REQUEST FOR INFORMATION DATE: July 22, 2016 NO.: RFI-213

Project Name: 15051-Webster University Interdisciplinary Science Building Project No.: 15051

Subject: Roof Deck Edge Verification

LEVEL 5 ROOF DECKING PLAN

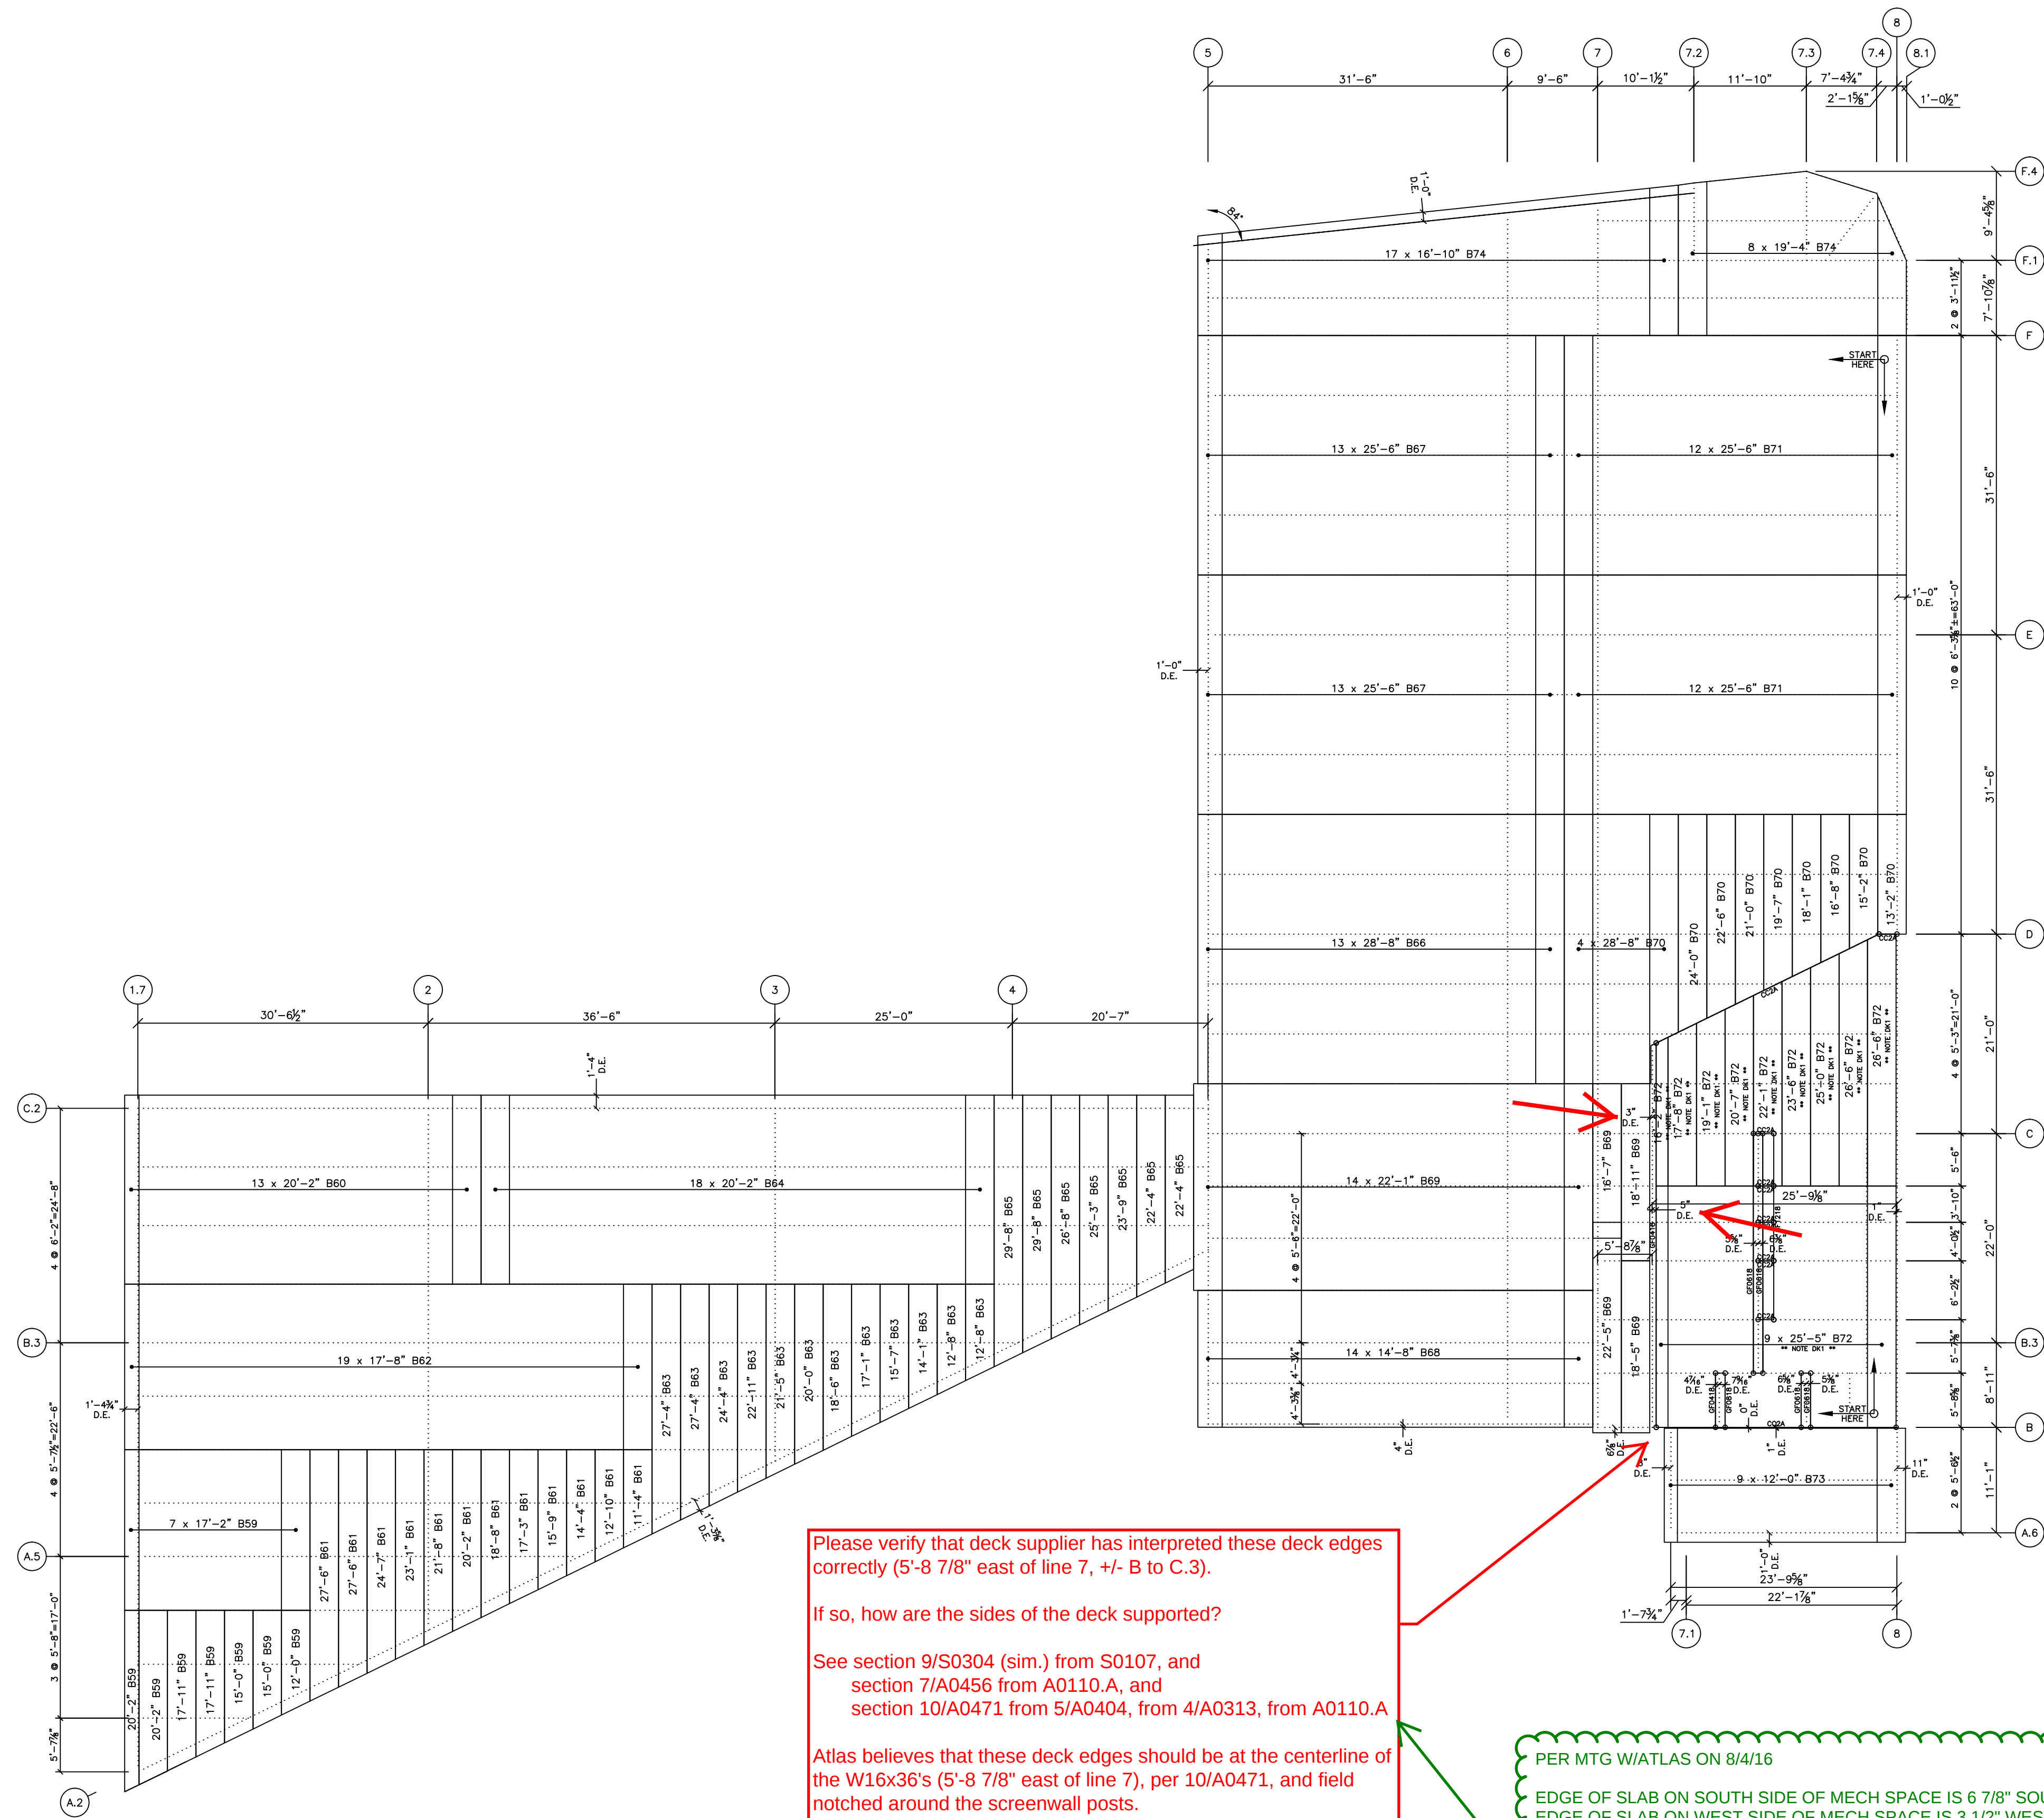
Please review the attached Vulcraft deck drawing and verify the deck edges shown approximately 5'-8 7/8" east of line 7 from approximately line B to line C.3.

- Per S0107, there is a line of W16x36's in this location supporting the screen-wall posts (9/S0304 sim.).
- Vulcraft's D7 drawing shows the deck stopping 3" west and 5" east of the centerlines of these W16x36's (if so, how are these deck edges supported?).
- Section 7/A0456 (from A0110.A) shows insulation going down to the top of steel, with the deck edges clinging to the beams?
- Section 10/A0471 (from 5/A0404, from 4/A0313, from A0110.A) shows both deck edges bearing on the top of steel at the centerline of the beams (¿ Atlas' believes this would be correct).

Please verify that deck supplier has interpreted these deck edges correctly (5'-8 7/8" east of line 7, +/- B to C.3).

If so, how are the sides of the deck supported?

See section 9/S0304 (sim.) from S0107, and section 7/A0456 from A0110.A, and section 10/A0471 from 5/A0404, from 4/A0313, from A0110.A

Atlas believes that these deck edges should be at the centerline of the W16x36's (5'-8 7/8" east of line 7), per 10/A0471, and field notched around the screenwall posts.

**SEE ATTACHED FOR ROOF EDGE LOCATIONS AND MODIFIED
DETAILS FOR MECH AREA PERIMETER.**

PER MTG W/ATLAS ON 8/4/16

EDGE OF SLAB ON SOUTH SIDE OF MECH SPACE IS 6 7/8" SOUTH OF GRID B

EDGE OF SLAB ON WEST SIDE OF MECH SPACE IS 3 1/2" WEST POST CTR

EDGE OF SLAB ON NORTH SKEWED SIDE IS 3 1/2" NW OF POST CTR

BEAMS SHIFT FROM POST CENTER TO ALLOW FOR 1" MIN OVERLAP OF EDGE ANGLE AND BEAM.

MECH AREA EDGE DETAILS WERE COORDINATED.
